The Department of Ecology’s Supplemental Modeling Report.
 A Critical Review.

Dr. Dave H. Milne PhD. July 2018

4. THE BUDD INLET ESTUARY; “NATURAL” AND MODERN.

?	
<p>Figure 4-1a. The Budd Inlet “Natural” (Pre-Modern) Estuary without the dam.</p>	<p>Figure 4-1b. Modern Budd Inlet with the dam. Source: SM Report Fig. 9, p. 34.</p>

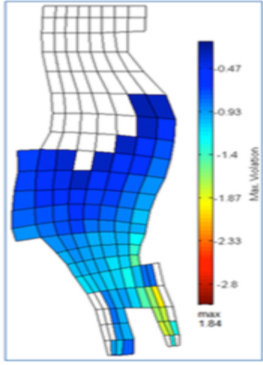
Ecology’s SM Report has several repetitions of the modern Budd Inlet (with the dam) grid map showing water quality violations throughout most of Budd Inlet (Fig. 4-1b). A comparable grid map of the “natural” (= pre-dam) estuary is nowhere to be found (Fig. 4-1a). If the “modern” map showed Budd Inlet to be much worse than the Inlet in its natural state, that would help make a case for removing the dam. Why haven’t the modelers shown us this?

The reason is that (in the SM Report, at least) the model shows that pre-modern and modern Budd Inlet are both about the same in terms of water quality violations, and that modern Budd Inlet with no dam would be astonishingly better than both. The model says that

1) the dam has kept Budd Inlet from getting significantly worse as human activity has intensified, and

2) all modern human activity would leave Budd Inlet's water quality about the same as it was in the natural pre-modern estuary if only the dam could be removed.

The first may or may not be true; the second is very unlikely.

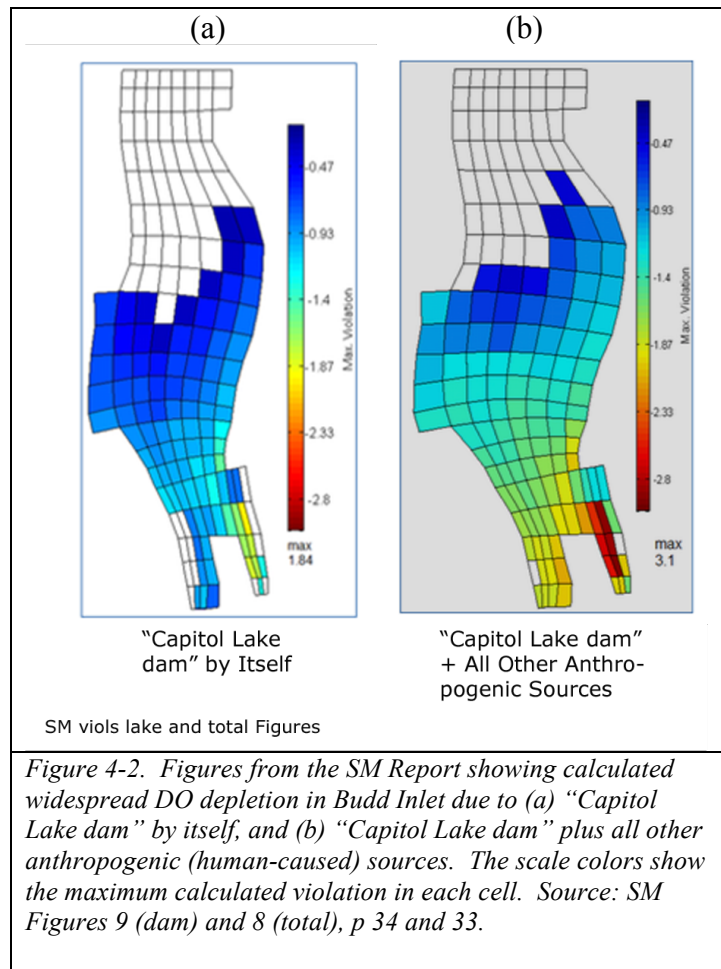
Figure 4-2a (left) shows the modelers' calculated portrayal of DO violations in modern Budd Inlet allegedly caused by “the dam” by itself (same as in Fig. 4-1b above). Figure 4-2b (right) shows the effects of all modern anthropogenic (that is, human-caused) agents of oxygen depletion -- “the dam,” the LOTT Wastewater Treatment Plant outfall between the KGY peninsula and Priest Point, several small creeks, and anthropogenic sources outside (external to) Budd Inlet.

The “all causes” map shows more of the Inlet affected by human activities and some areas more severely affected (redder and yellower colors) than would be the case with “the dam” by itself. In these grid maps, each colored square shows the worst DO “violation” of the entire simulated year (January 25 – September 15, 1997). Recall that these maps are made via a massive computer search of the water in each grid square for dissolved oxygen levels that are lower than the water quality standard. The square is “flagged” (colored) if a violation is detected but left uncolored if there are never any violations. The square would be flagged even if a violation occurred just once, at just one depth, and lasted for just six simulated minutes, and would be indistinguishable on the map from a violation of that size that occurred all summer long at that location at all depths.

The overall blue color of most violations in Figure 4-2a shows that the about half of the widespread calculated violations “caused” by the dam are the smallest possible “violations.” Small, ephemeral, and prone to calculating error though they may be, they create the visual impression that Capitol Lake has a huge negative effect on Budd Inlet.¹

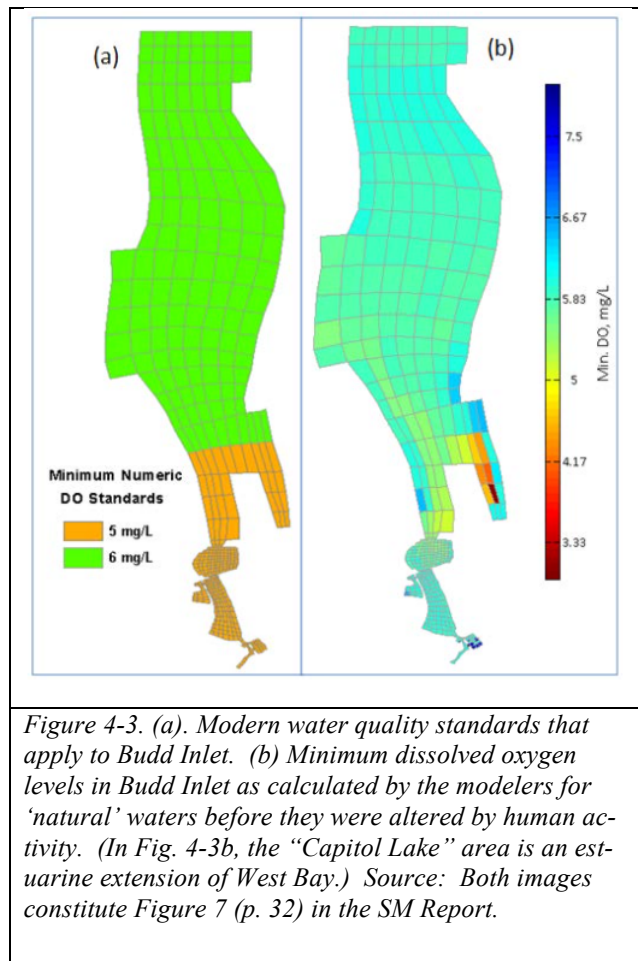
The SM Report does contain a “natural estuary” grid map – but not like the one that should fill the blank in Figure 4-1. It’s shown in Figure 4-3, which reproduces Ecology’s Figure 7 from the SM Report (p. 32). The leftmost grid map (a) shows the dissolved oxygen standards for Budd Inlet, namely 5.0 mg/L in the southernmost reach (orange grid), 6.0 mg/L in all of the rest (green grid). The rightmost map (b) shows the calculated “natural” pre-modern Budd Inlet estuary with no anthropogenic (human-caused) sources of DO depletion, including “no dam.”

The pre-modern estuary is shown in a format that makes it impossible to see at a glance whether its water quality is better or worse overall than that of modern Budd Inlet. The scale that accompanies it shows the minimum level of DO present at each location when the worst violations occurred – not the sizes of the violations themselves, as do the scales of all other grid maps of modern Budd Inlet (see Figure 4-2 above). Readers must figure out for themselves from the subtle gradations of color whether and where parts of the natural estuary were “in violation.”

This critically important Figure is described by just one sentence in the SM Report; “*The minimum DO under natural conditions is predicted to fall below the water quality standards in portions of Budd Inlet, with lowest DO predicted in East Bay.*” (p. 32, SM Report). One could hardly guess that this bland presentation shows the water quality in the pre-modern inlet to be no better than that in modern times.

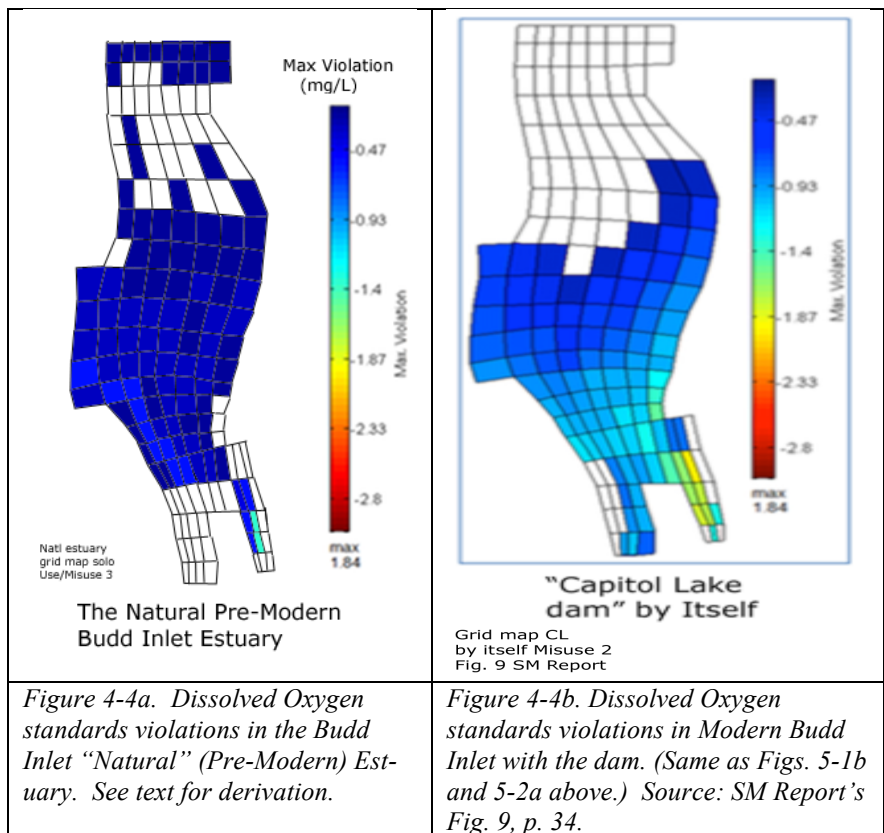
It is possible to convert Figure 4-3b to the format and scale of all of Ecology’s other grid maps of Budd Inlet for easy comparisons at a glance. The result of that conversion is shown in Figure 4-4a (left). That is the dissolved oxygen violations grid map that should have been in the empty frame of Figure 4-1a. *It is a grid map that the Department of Ecology hoped the public would never see.*

Figure 4-4a shows that calculated water quality violations were about as widespread in the pre-modern undammed “natural” estuary as they are in modern Budd Inlet (Fig. 4-4b). If an interpretation were needed in just one sentence, it would be this; “*Despite decades of intensifying human activities around its shores and in its watershed, modern*

Budd Inlet with the dam is shown by the model to be about as unimpaired as it was in pre-modern times.”

It is important to recall how the “modern” Budd Inlet grid map (Figure 4-4b) was created. During that simulation, calculated DO levels in “modern” Budd Inlet were compared, grid cell by grid cell, depth by depth, moment in time by moment in time, with their counterpart DO levels in the “natural” estuary (Fig. 4-3b). Wherever and whenever the “natural” estuary’s waters were in violation of modern DO standards (as shown in Figure 4-4a), the “modern” Budd Inlet water was compared with the “natural” water to see if its DO levels had dropped even lower. If so, a violation was flagged for that instance. The “modern” Budd Inlet map showing the effect of the dam (Figs. 4-2a and 4-4b) therefore

shows *how much worse* the Budd Inlet water has gotten compared with its condition in the pre-modern Inlet. Over most of its blue extent, it is not much worse than during “natural” times. (In fact, “blue” violations represent about 0.20 mg/L, a difference so small that one can hardly measure it in the field.) And in some areas (for example the uncolored northern two tiers) the water quality in modern Budd Inlet is the same as (or better than) that in the “natural” estuary. And always recall that “blue” violations are the most likely ones to be errors resulting from the computer’s large “margin of error” (see Chapter 3).

Figure 4-5. Budd Inlet DO violations; no dam, all other anthropogenic nutrient sources present. Source: SM Report’s Figure 17, p. 40.

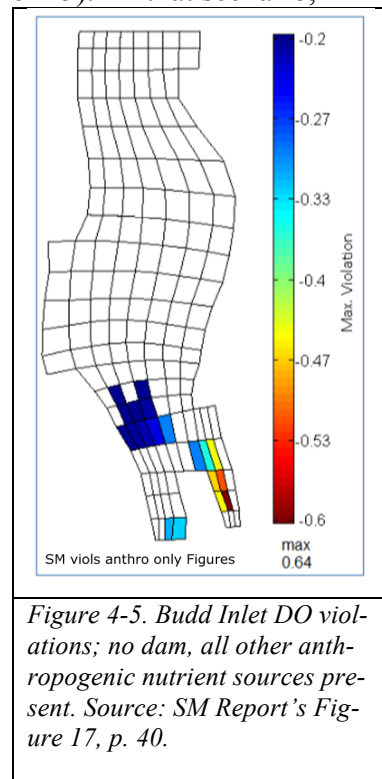
The SM Report portrays Budd Inlet “without the Capitol Lake dam” – a grid map of the effect of removing the dam on the Inlet’s water quality (Figure 4-5). In that scenario, tidewater extends from West Bay all the way up the present-day Lake basin to Tumwater Falls. The map shown is actually not just the result of removing the dam; it also shows the effects of all other human-caused nitrogen inputs to Budd Inlet.

At face value, this “modern estuary” grid map shows that removal of the dam makes the estuary “worse” in DO terms in only a few areas compared with its “natural” condition (Fig. 4-4a); at the “big blue patch” opposite Priest Point Park and (as always) in East Bay.

A closer look at the bewildering array of simulations of different scenarios that accompany it makes it seem likely that the “no-dam-by-itself” scenario is artificially packaged to look good (in fact “too good to be true”) and that the *real* “Capitol-Lake-dam-by-itself” scenario is much better than presented in Figure 4-4b above. But first, it is useful to keep in perspective the sizes of the anthropogenic factors affecting Budd Inlet.

The second row in Table 4-1 was inserted by me. That is a scenario that shows the “effect of no dam” by itself. Ecology’s much-repeated Figure 17 (SM Report; Figure 4-5 above), supposedly showing that, actually does not. It shows the effect of no dam but with all other sources contributing their full loads of anthropogenic nitrogen. I have also indicated in Row A (“with dam by itself” scenario) the sources that Ecology should have used or eliminated to simulate that scenario. (Perhaps these were the values that Ecology actually did use; however they are not listed in the SM Report.)

Figure 4-6. Sizes of nutrient inputs to Budd Inlet from four categories of sources. See Fig. 6-4, Chapter 6, for a detailed derivation of this Figure.

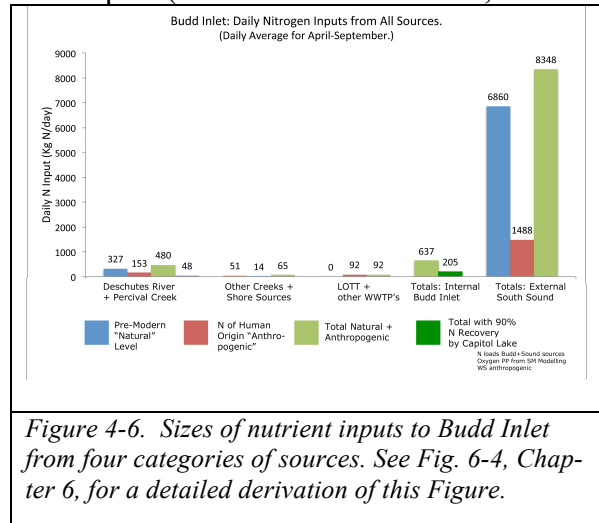
Figure 4-6 is a thumbnail sketch of the sources of nutrient nitrogen to Budd Inlet. (For close-up details, see Chapter 6.) The sizes of the human-caused inputs are shown by red bars, natural inputs are shown by blue bars, and totals of the two by light green bars.

The first take-away message is that the “external” inputs (from outside Budd Inlet, far right) are gigantic compared with all internal shoreline sources discharging directly into Budd Inlet. The second take-away message is that in all cases, the human-caused inputs (red bars) are smaller than the natural inputs (blue bars). The effect of human activity has been to add a thin “veneer” of additional nitrogen to large natural components that existed before intensive human activity began affecting the water quality. Numbers (not readable in this miniature Figure) are: Deschutes River 327 N, 153 A; Other shoreline sources 51 N, 14 A; LOTT Plant 0 N, 92 A, and External 6860 N, 1488 A; where “N” is the natural daily nitrogen input and A is the anthropogenic daily load in kg N/day. (The Deschutes River figures are the loads before Capitol Lake reduces them by 50-90%).²

4-6d. Figure 4-7; Grid Maps of the Dam/No Dam Simulations.

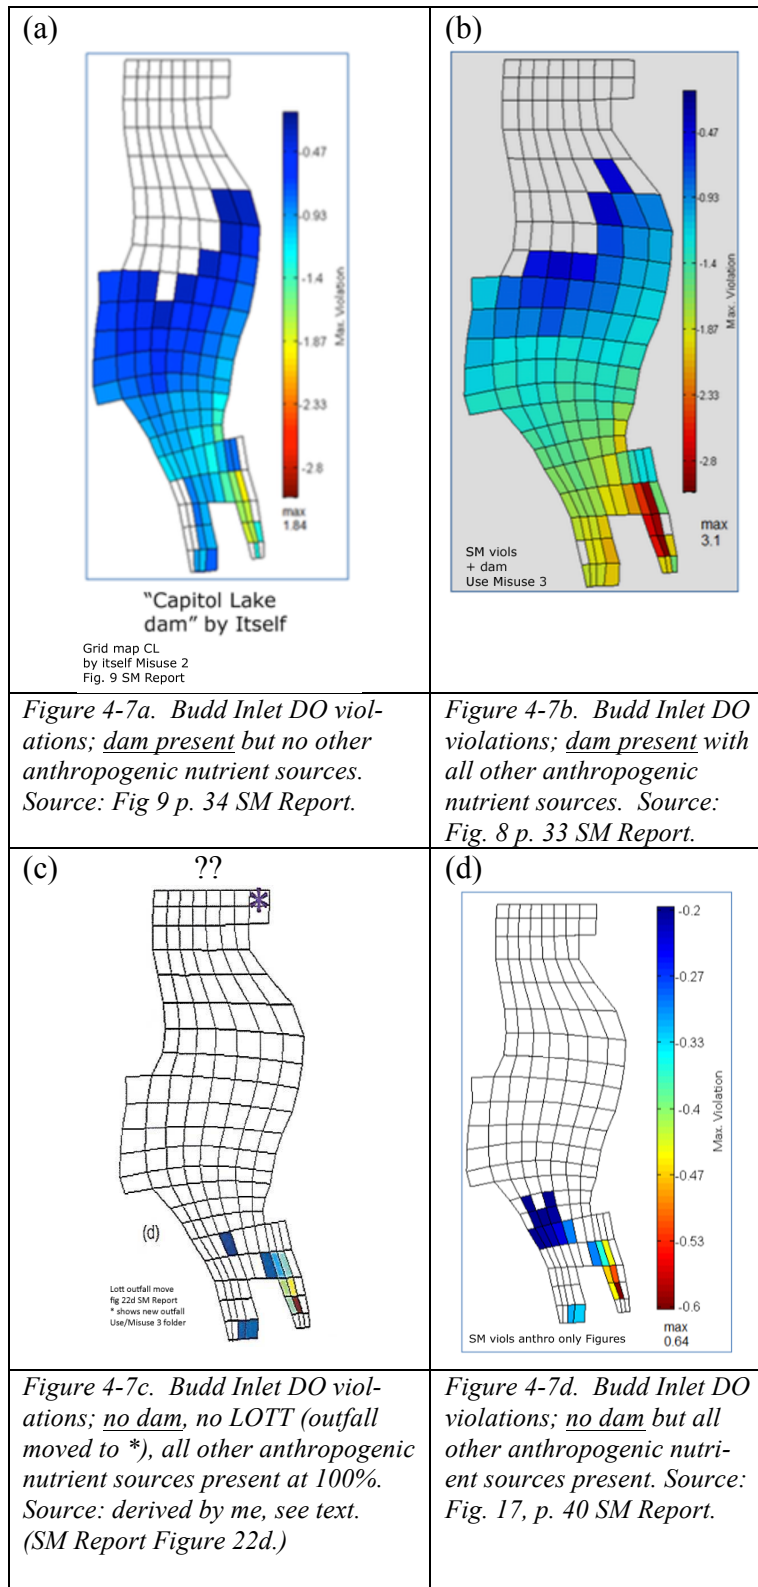
The outcomes of my effort to compare “dam” vs “no dam” effects on Budd Inlet are shown in Figure 4. The four grid maps are juxtaposed such that the upper row shows Budd Inlet with the dam present over a lower row that shows Budd Inlet with the dam absent. The left column shows the dam/no dam effects isolated by themselves, the right column shows the dam/ no dam effects in company with all other nitrogen source inputs operating.

Figure 4-7d – Budd Inlet with no dam but all other anthropogenic sources present – implies almost no DO standards violations at all. However recall that grid maps formed by comparing the modern situation with the “natural” situation show *how much worse* the modern situation is than the natural situation. Figure 4-7d shows that whatever the modelers did to remove the dam from the model didn’t change the “natural” background picture very much. That is not surprising; the “no dam” simulation uses the same gusher of Deschutes River nitrogen nutrients as was used in the “natural” simulation (Fig. 4-4a). If the

violations themselves were shown, the grid map of Budd Inlet with no dam would be as “blue” as Figure 4-4a with much more color in East Bay.

The effect of removing the dam by itself *and with no other sources complicating the picture* is not shown in the SM Report (see Row B, Table 1). I created that Figure (4-7c) from the information in Table 1. The result -- Figure 4-7c -- shows almost no negative effects at all attributable to removing the dam. By dramatic contrast, its counterpart Figure 4-7a shows (small) negative effects attributable to the dam by itself almost everywhere. To an ecologist’s eye, the “no dam by itself” outcome is just plain “too good to be true.”

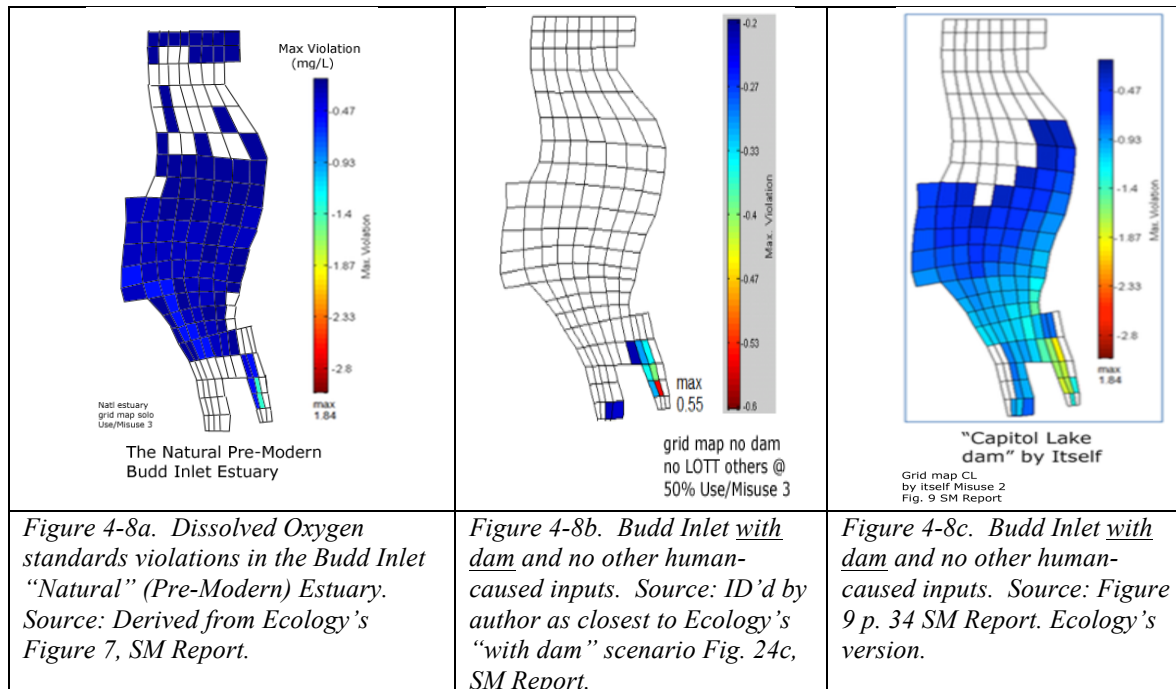
Is it possible to check up on Ecology’s “Budd Inlet with dam by itself” (with no other anthropogenic sources) claim (Fig.4-7a)? To do that, one would need to find the scenario in Table 1 that most closely approaches the conditions shown in Row A; that is Deschutes River with 90% of both anthropogenic and natural nutrient loads reduced by Capitol Lake and the three other input sources at zero, zero, and zero.

The closest approach to a “dam by itself” scenario in Table 1 is Row H. The Deschutes River anthropogenic nitrogen input is reduced by 50% (mimicking the effect of Capitol Lake), the LOTT input is reduced to zero, and the very small and localized “Other creek” sources are reduced by half. The huge external input is left intact at 100%; there’s nothing we can do about that. The grid map resulting from that simulation is shown in Figure 4-8b. For our grand finale, the “natural Budd Inlet estuary” is also repeated for comparison in Figure 4-8a.

Recall that the two portrayals of “Budd Inlet with dam” do not show the whole story. Each shows the additional violations that would be “piled on” the natural estuary; that is, how much worse off Budd Inlet is with the dam than it would be without it. The complete grid map of violations would be “blue all over” (the natural estuary map) with even more blue (and other colors) added by the two scenarios to the right. Even piled on, the additional violations caused by “the dam” in either case (Fig. 4-8b and 4-8c) are so tiny (blue) that composite violations map shows “no real problem here.”

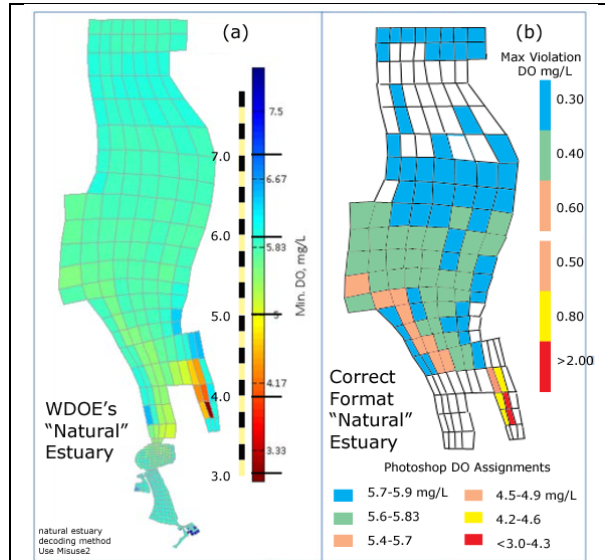
First I constructed a black-and-yellow scale bar and scaled it to fit the modelers’ erratic color scale gradation (shown in Figure 4-9a). I then used the “polygonal lasso” selection tool to carefully select the interior color of one square on the image in Figure 4-3b, taking care not to include any parts of the grid lines. I then clicked “Similar” under Photoshop’s Selection Menu. This highlights (“selects”) every grid square in the Figure that has a “similar” color *and also that color on the modelers’ scale bar.*

The selected similar color on the modelers’ scale always spanned a small range whose upper and lower limits could be measured with my own calibrated scale. I hand-annotated all selected grid squares on a printed copy of the grid, noted the DO range indicated on the scale, and repeated the process by deselecting the image and selecting another grid square. (Notation by hand was easier than storing all of the values in computer memory at this stage.) I continued this until every grid square on the printed map was filled. Later in the procedure I transferred the key colors of the violations to a preliminary computer-generated grid map – Figure 4-9b – as described below.

Early in this work it was not possible to use the same colors for violations as those used by the modelers. I assigned colors to the violation categories as shown in Column E and created a preliminary grid map using those colors (Figure 4-9b). Subsequently I created the finished natural estuary grid map (Figure 4-4a) by converting the preliminary colors to those used by the modelers.⁴
